6.2 103 BEACH STREET PORT MELBOURNE

LOCATION/ADDRESS: 103 BEACH STREET PORT MELBOURNE

PREPARED BY: SCOTT PARKINSON, PRINCIPAL PLANNER

1. PURPOSE

Fig 4: Graphical representation from the submitted Design Response showing the surrounding built form context

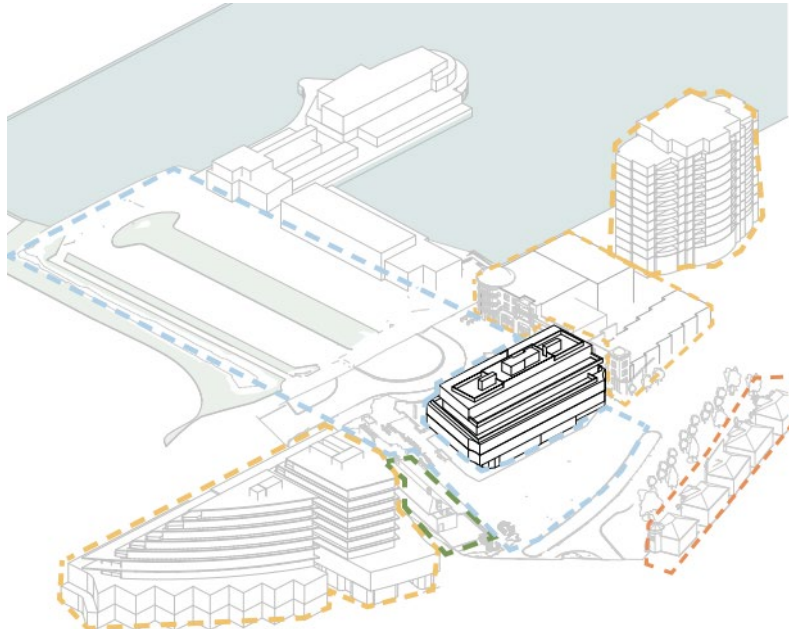
- 14.28 This graphical representation of the surrounding area illustrates that the Carr Architecture proposal would be a comfortable fit with the surrounding area. The diagram shows that the proposed building would have a height that is comparable to the built form to the west and be compatible to the larger buildings that are existing or are to be developed nearby. It also importantly shows that a large and clear separation would be provided from the lower scale residential area to the north. This ensures that there would be no adverse impact on the character of the residential precincts of Beacon Cove.

- 14.29 While the overall concept of the five storey building is supported, planning officers are concerned that the setbacks to the upper levels do not adequately address off site amenity impacts. Planning Officers agree with the comments from Council's Urban Designer that the shadows cast from the additional levels would be reasonable. The submitted shadow diagrams show that there would be no additional impact to adjoining balconies and would not affect the key public realm spaces of the Bay Trail and Waterfront Plaza. However, there are concerns in relation to the visual bulk that would be created from the upper levels.

Fig 7: Cut out of the original Key Infrastructure proposal which shows the existing car park has spaces within the title boundary of the subject site.

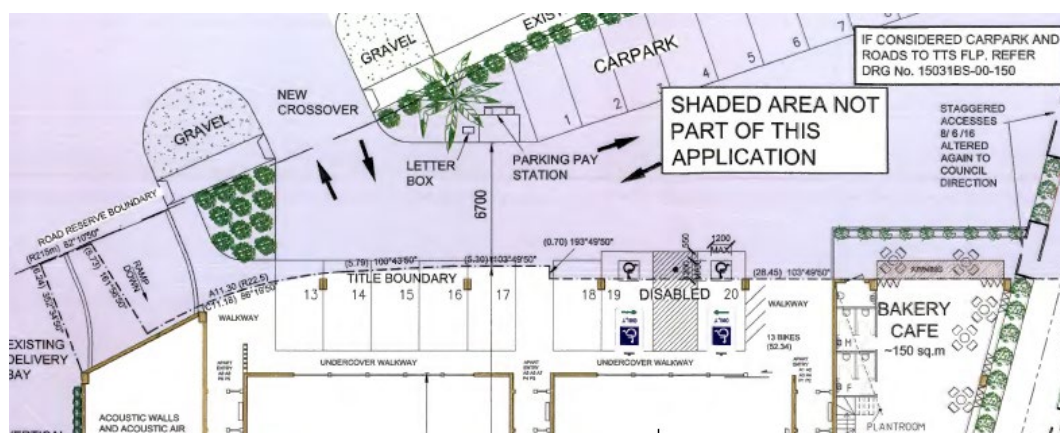
- 14.50 There is a significant issue for the existing car park where the spaces along the southern side of the car park are partly located within the title boundary of the 103 Beach Road site. This is shown in the plan below which is taken from the plans for the original Key Infrastructure application. This was a key consideration of the approval of the application.

- 14.51 For the current approval (Wood Marsh) the endorsed plans sought to resolve the car parking issue by providing an indicative layout of how a car park will still be able to be provided on the land to the north of the subject site. However, the planning permit that was issued did not include any final design for the car park or any means how the redesigned car park would be constructed.
